Page 1
Modification List 7/12/04
RFP GPO-EP2004

1. This Modification List 7/16/04 to Request for Proposal (RFP) GPO-EP is issued as a result of questions received regarding the posted 23 June Draft RFP. The page numbers reflect the manner in which the RFP was prepared and printed by the Paper and Specialized Procurement and Sales Division and may not precisely follow the manner in which the RFP was downloaded by interested parties.

EP Book Cover Sizing Diagram

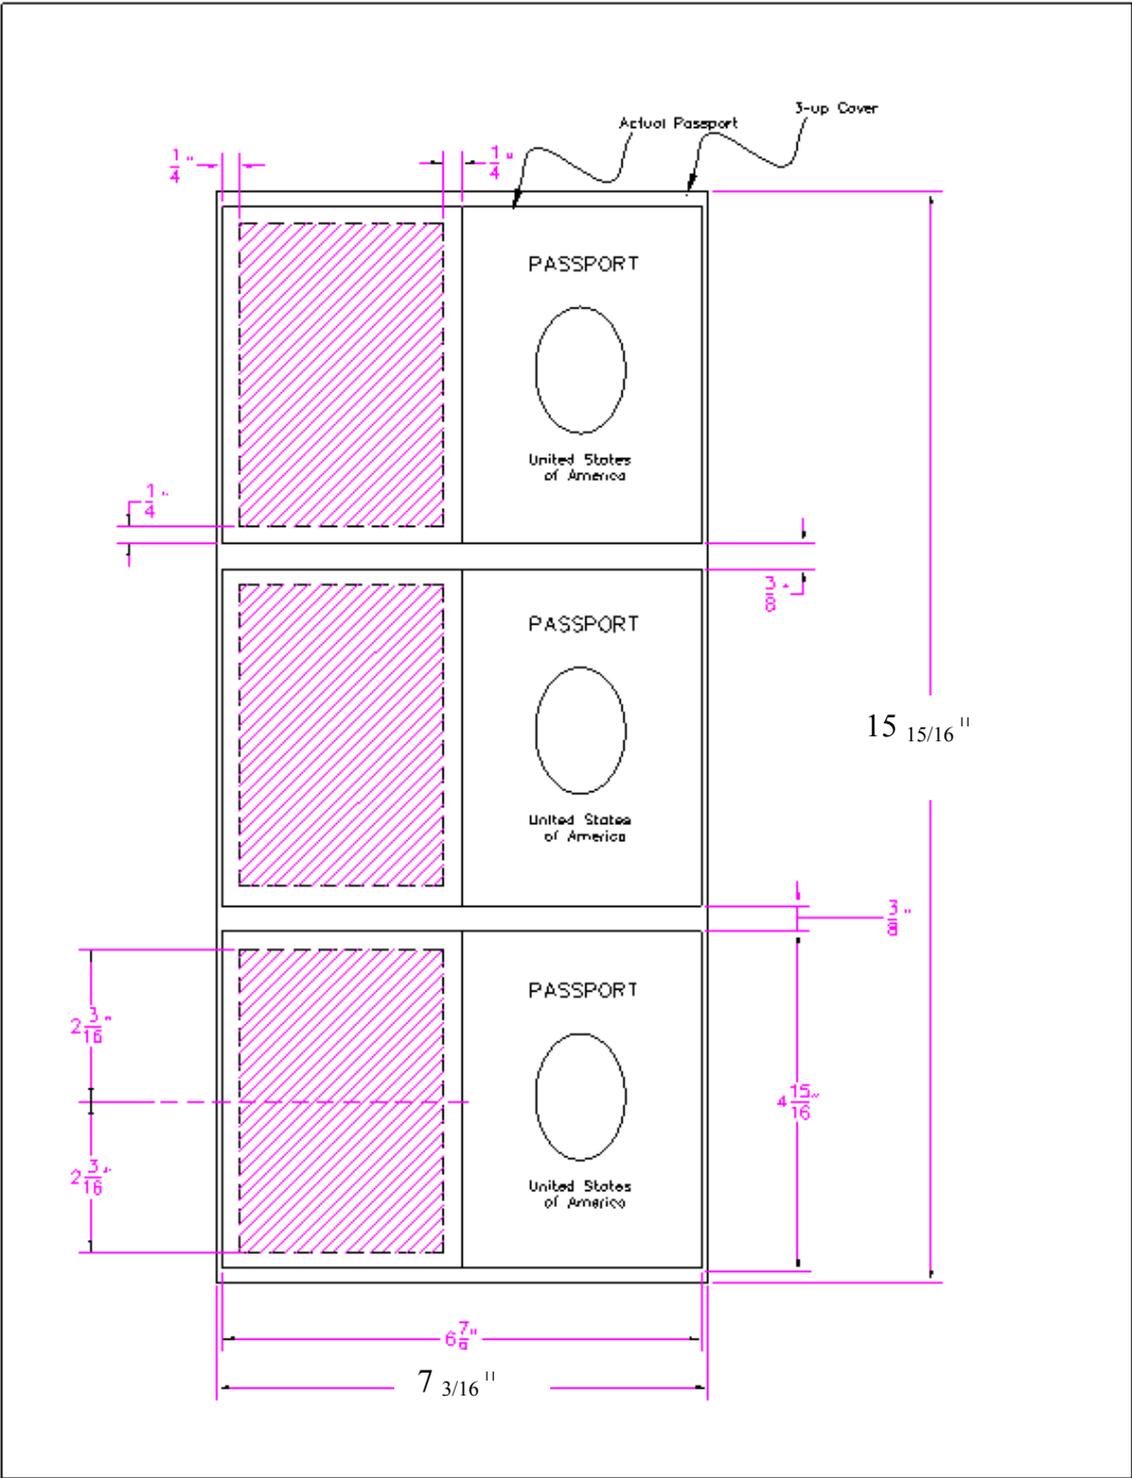
12	<u>In Appendix D Characteristics for Reader/Writers</u>		DELETED: Part 2: Additional Desired Reader/Writer Characteristics for Planned Implementations
13	<u>In Section C – Specifications/ Statement of Work: Starting on Line 696 Line</u>		DELETED TEXT: VERIFY (Line 696) READRECORD (Line 707) WRITERECORD (Line 708)
14	In Section C APPENDIX C -- EP Book Cover Sizing		ADD DIAGRAM: EP Book Cover Sizing Diagram (See Below)
